Ref: 740.DA5.320.002

RESPONSE TO INFORMATION REQUEST LETTER

DEVELOPMENT APPLICATION FOR A MATERIAL CHANGE OF USE – DEVELOPMENT PERMIT FOR EXTRACTIVE INDUSTRY AT THE EXISTING BROMELTON NORTH QUARRY ON LAND SITUATED OFF SANDY CREEK ROAD, BROMELTON, QLD 4285, PROPERLY DESCRIBED AS LOT 1 ON RP98576

OFFICE OF COORDINATOR GENERAL REFERENCE: AP2022/022

Site Context Plan

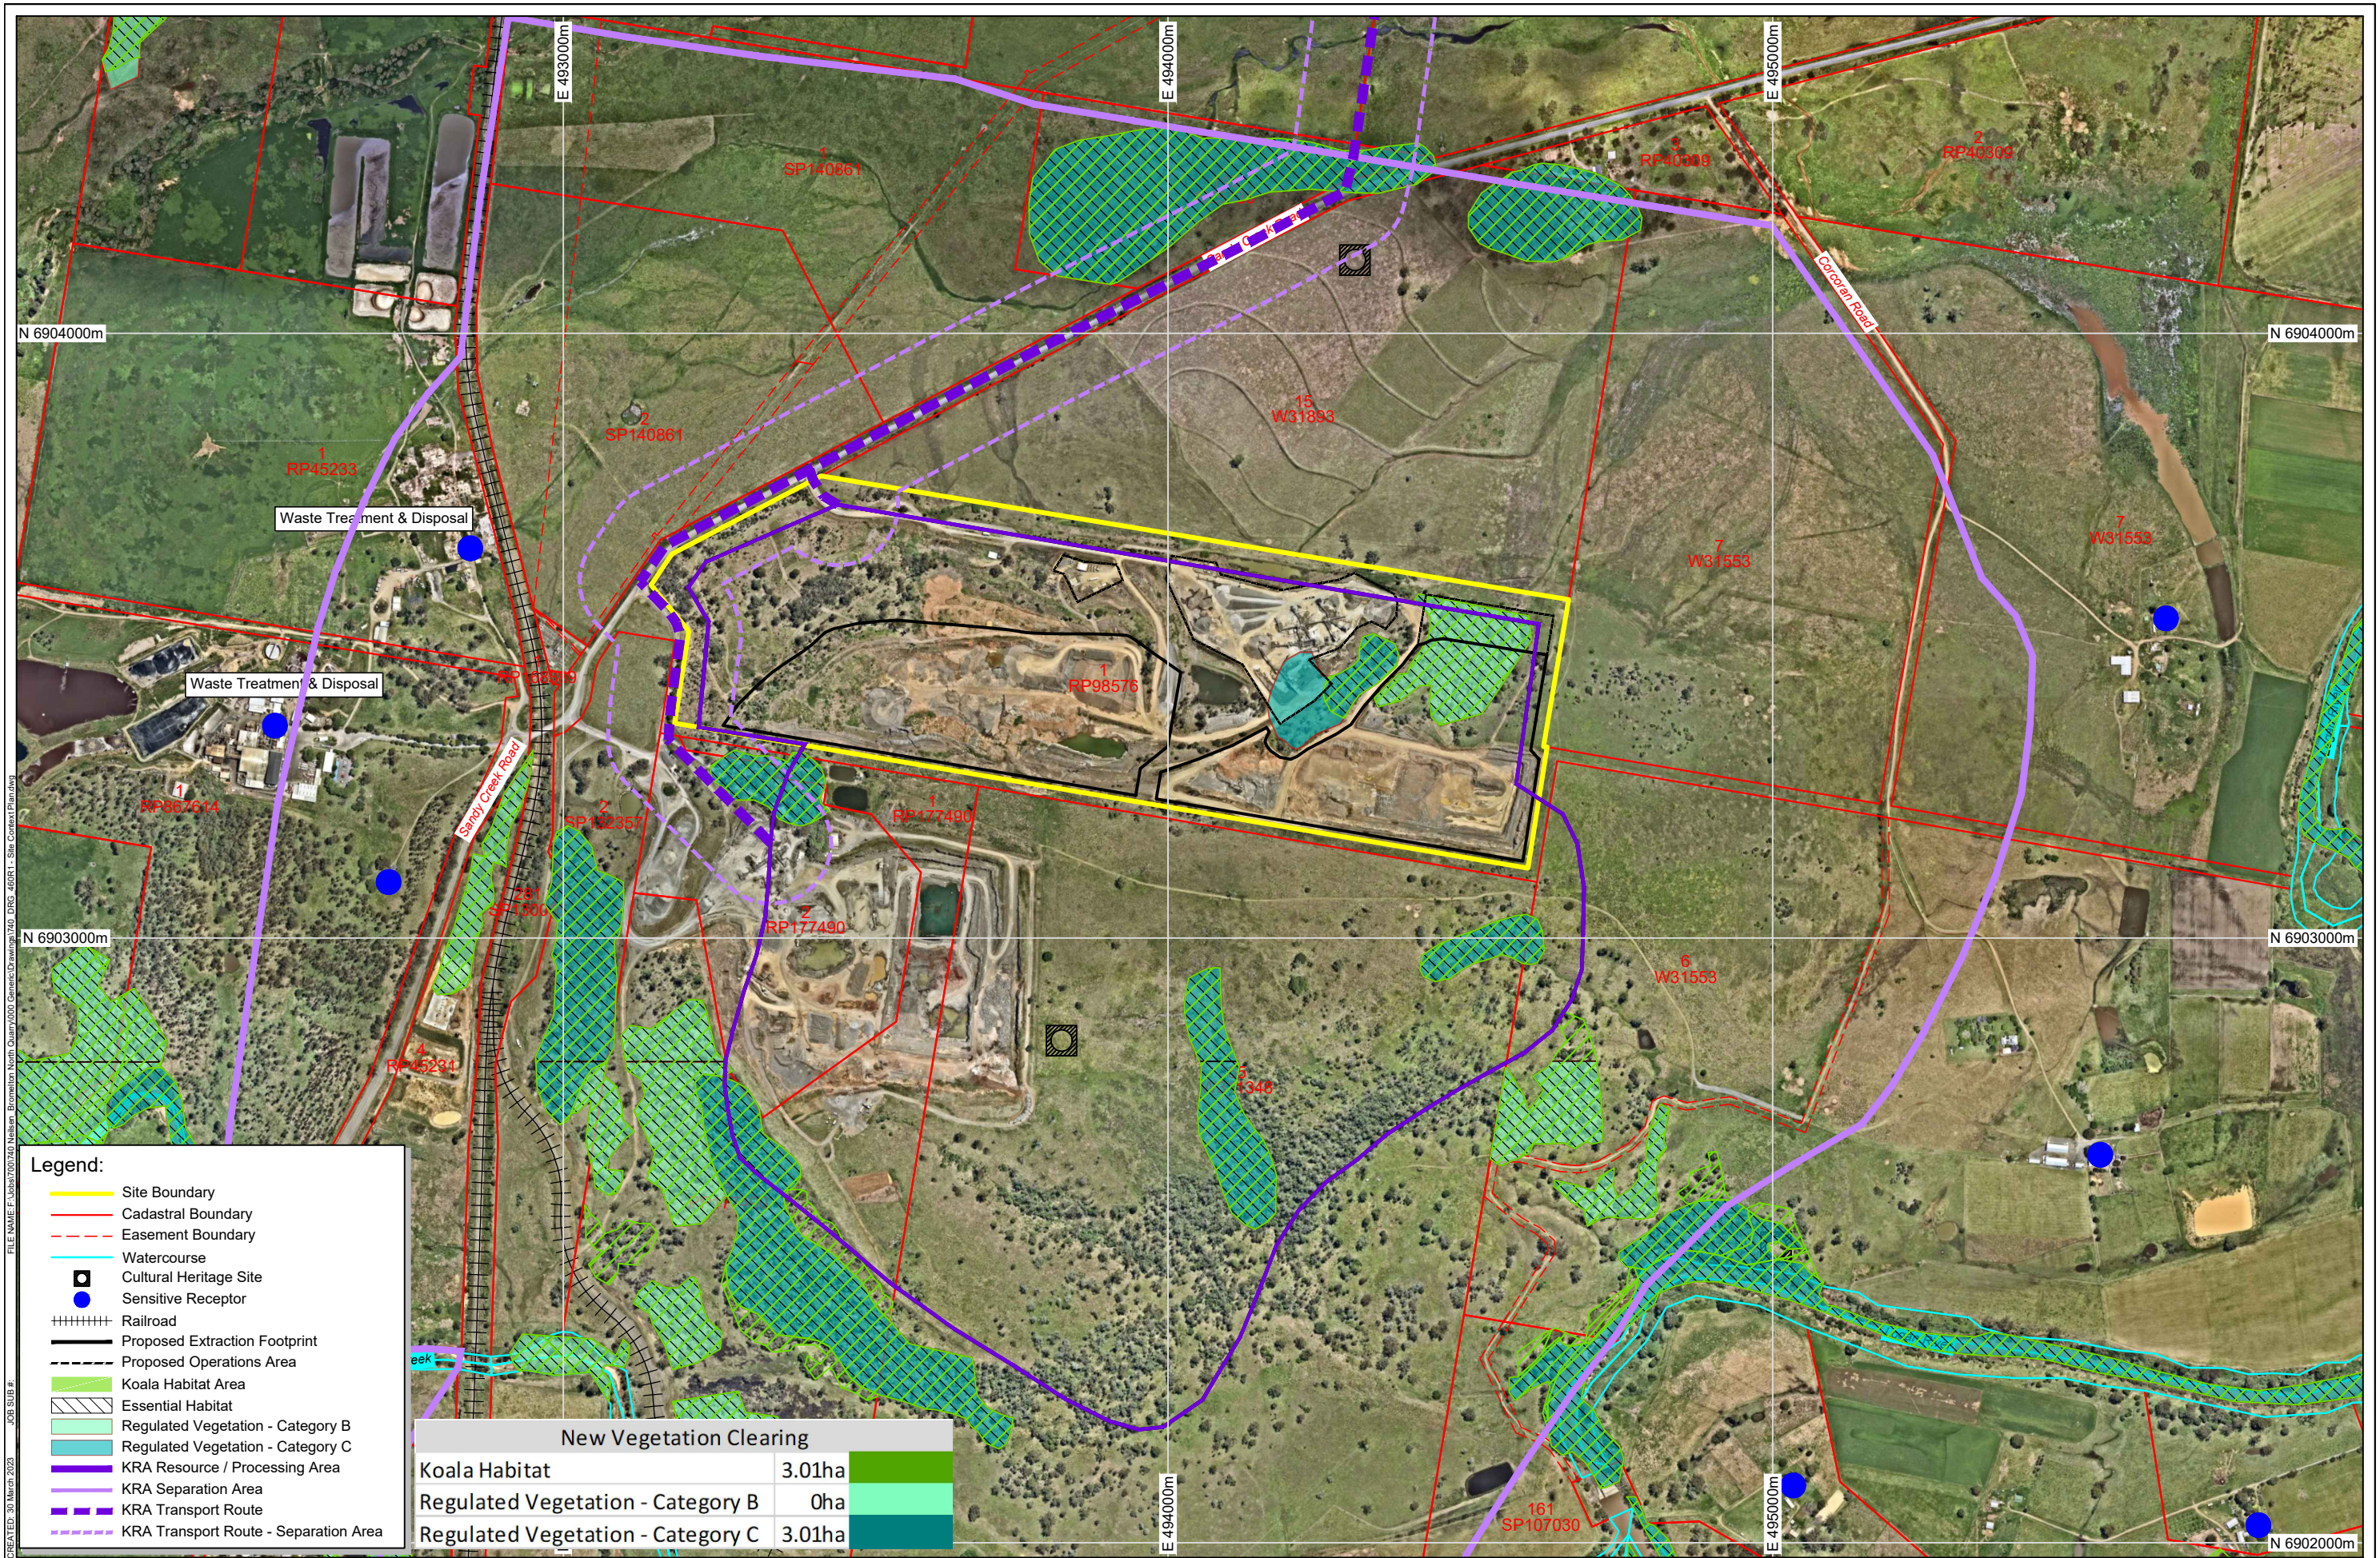
Item 7 (1) The proponent is requested to:

- a) *identify any relevant environmental values, cultural heritage values and community values both on the subject site and in the immediate surrounds;*
- b) *identify any mitigation or management strategies that will be implemented to protect these identified values from adverse impacts.*

Item 8 (1) The proponent is requested to submit a vegetation clearing table which identifies:

- a) category of vegetation to be cleared
- b) amount of vegetation to be cleared by category
- c) level of assessment required.

Item 9 (1) The proponent is requested to *review the information sheets and provide updated information that:*

- identifies the applicability of the Nature Conservation (Koala) Conservation Plan 2017 to the proposed development*
- identifies how the proposed development will comply with the relevant clearing requirements prescribed in Part 3 of the Nature Conservation (Koala) Conservation Plan 2017.*

A new plan has been prepared which comprises relevant environmental, cultural heritage and community values located in both the Bromelton North Quarry and the immediate surrounding area (refer **Appendix E – Site Context Plan**).

The applicable values include: Remnant Vegetation (remnant and regrowth), Core Koala Habitat, Key Resource Area, sensitive receptors, the adjacent quarry site boundary, other adjacent uses, surrounding creeks/rivers and registered cultural heritage sites.

Reference is made to the plan prepared in response to Item 7 (refer **Appendix D – Site Context Plan**). This plan shows the extent of mapped remnant (Category B) and regrowth (Category C) vegetation on the site.

The proposed development intersects with 3.01 hectares of regrowth vegetation (Category C), all of which is proposed to be cleared.

Reference is made to the plan prepared in response to Item 7 (refer **Appendix D – Site Context Plan**). This plan shows the extent of mapped Core Koala Habitat on the site. The proposed development intersects with 3.01 hectares of Core Koala Habitat, all of which is proposed to be cleared.

Exclusion and Isolation Zone

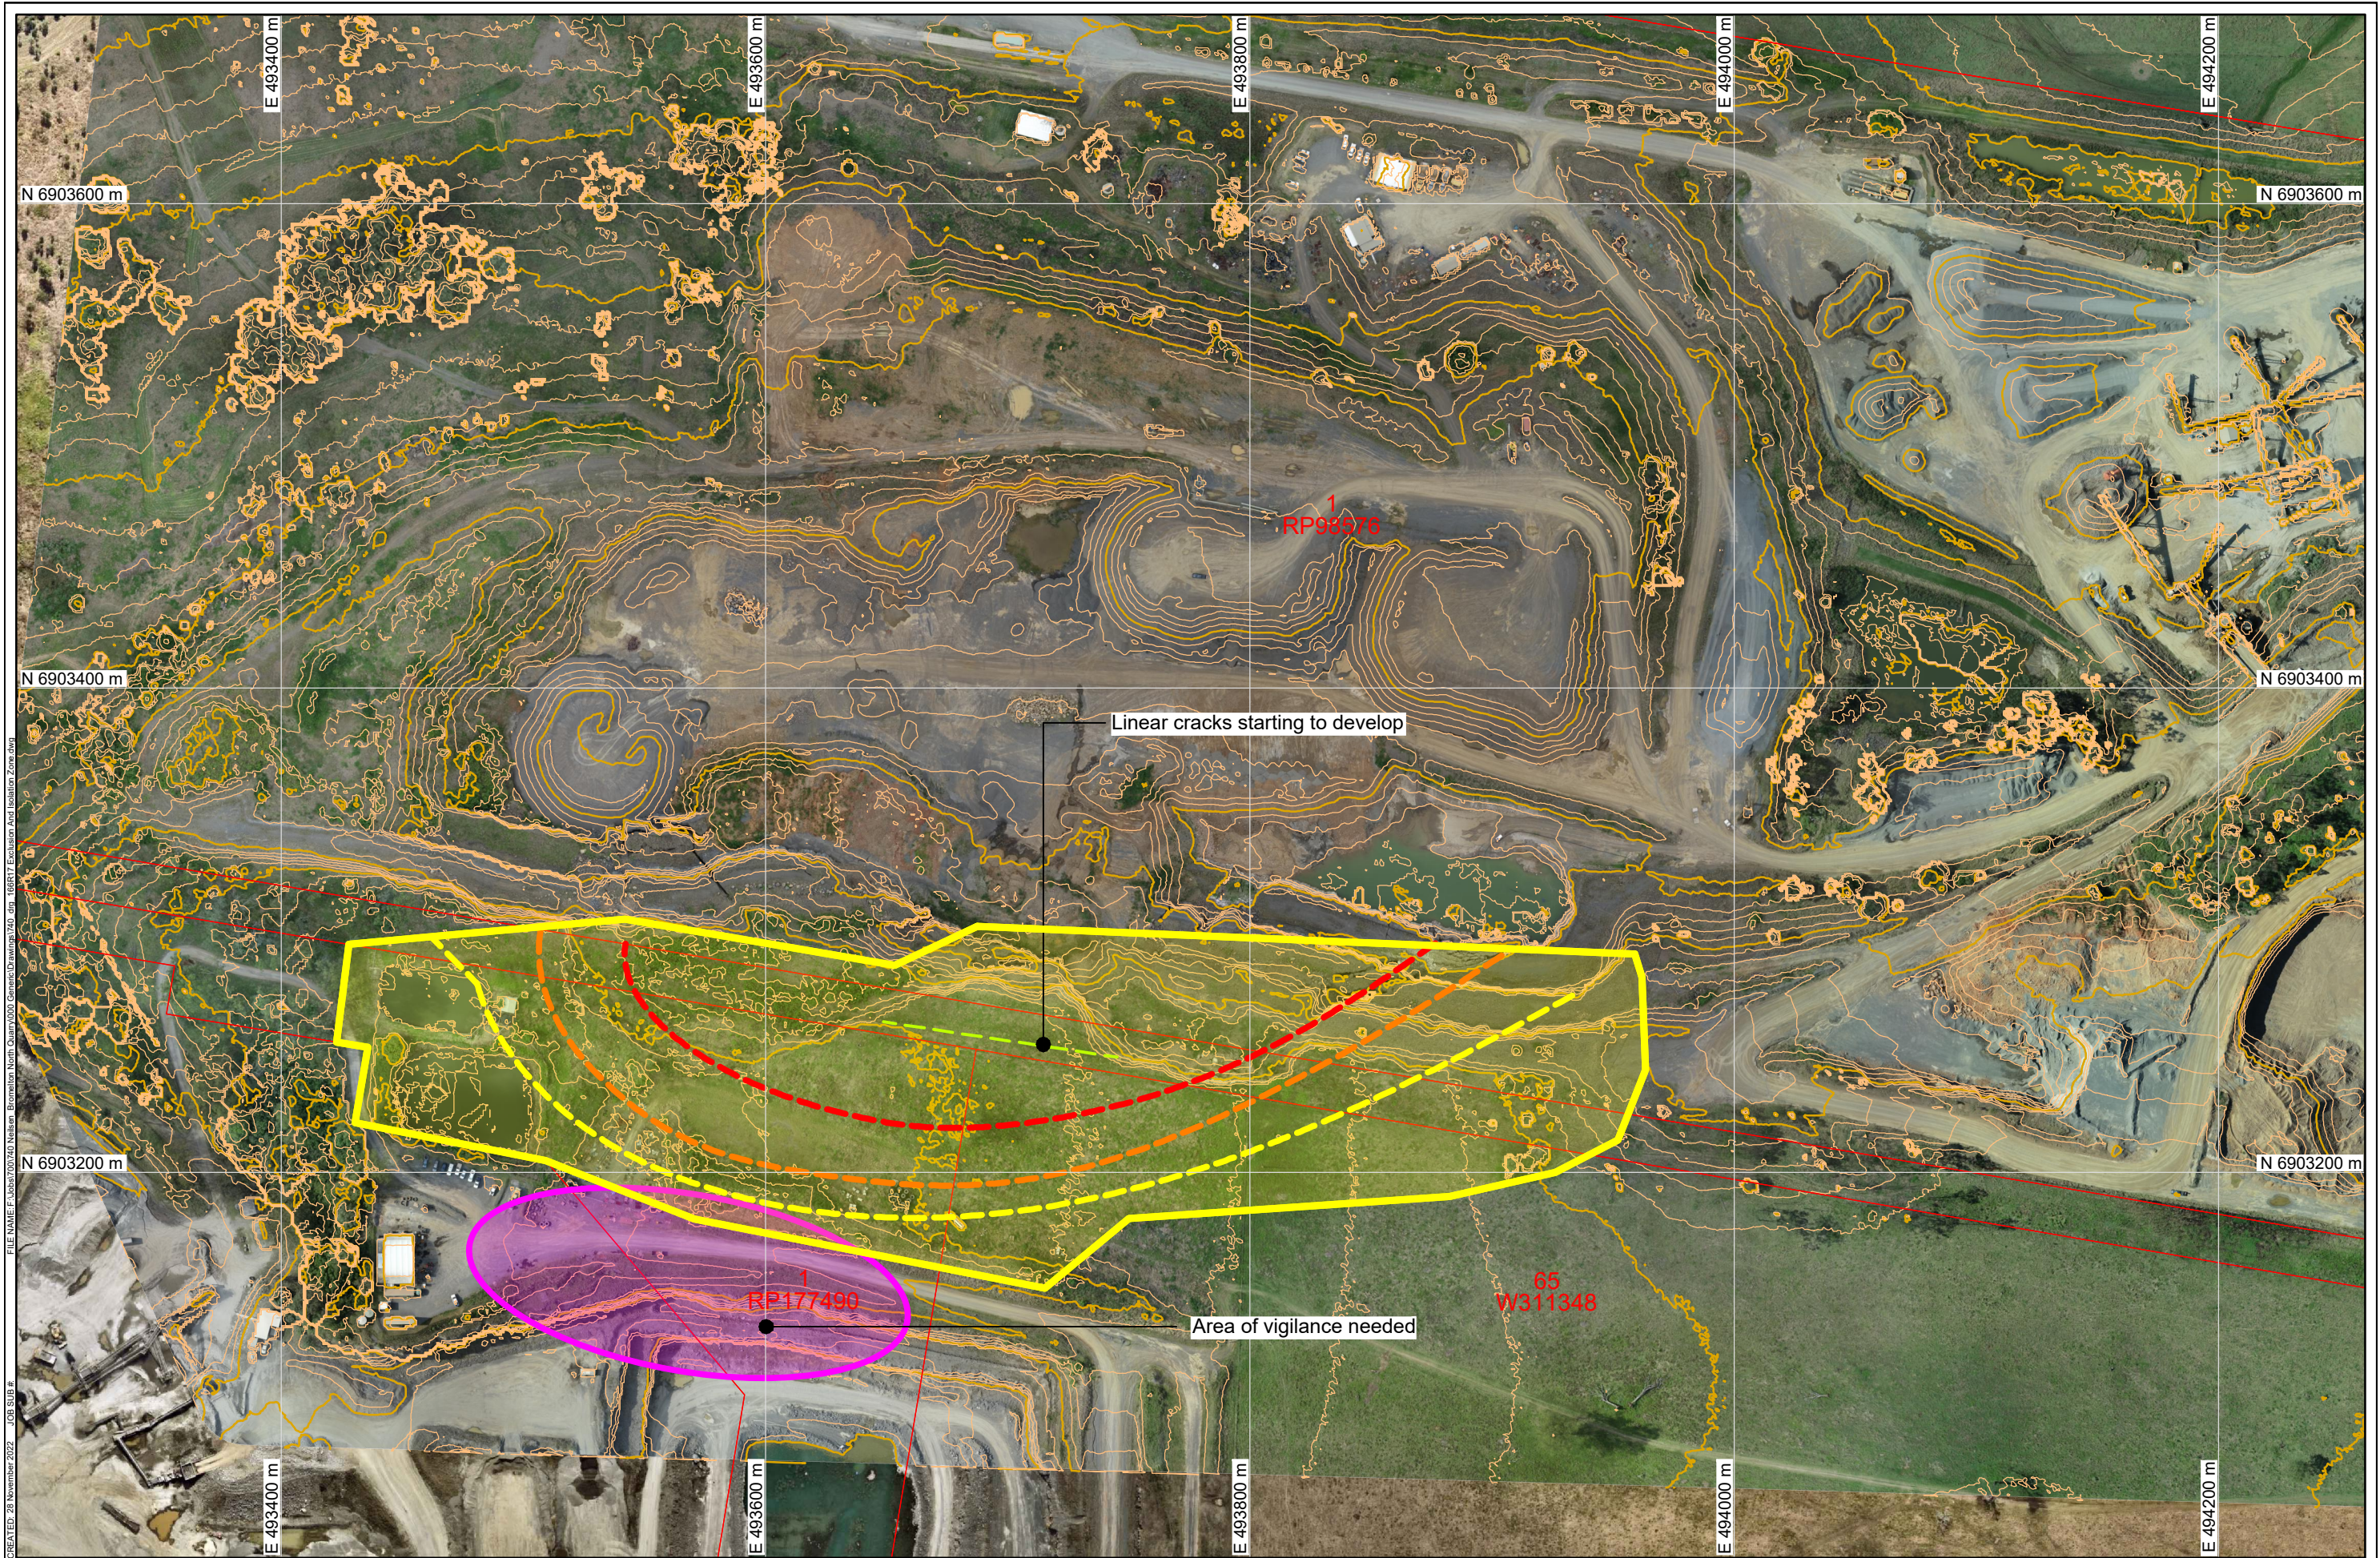
- Landslip: Neilsens' has been working closely with the Department of Environment and Science ('DES') in relation to a landslip on the southern wall of the West Pit. To date this matter has involved liaison with landowners on either side of the property boundary, Council, DES, Department of Resource and Department of Agriculture and Fisheries.

An exclusion and isolation zone has been established to assist in managing the landslide. This area is re-assessed as stabilisation works are undertaken and risks are re-evaluated. The current exclusion and isolation zone has been attached for the Departments information purposes (refer **Appendix F – Exclusion and Isolation Zone**).

Influence on current Development Application: A final geotechnical solution is yet to be agreed between all parties. However, intermediate steps have been taken to stabilise the slip, including filling within the West Pit void. The final geotechnical solution will define the land use approval process required (i.e., Operational Works through Council or MCU through the Department). It is premature to include or exclude this area from the extraction footprint.
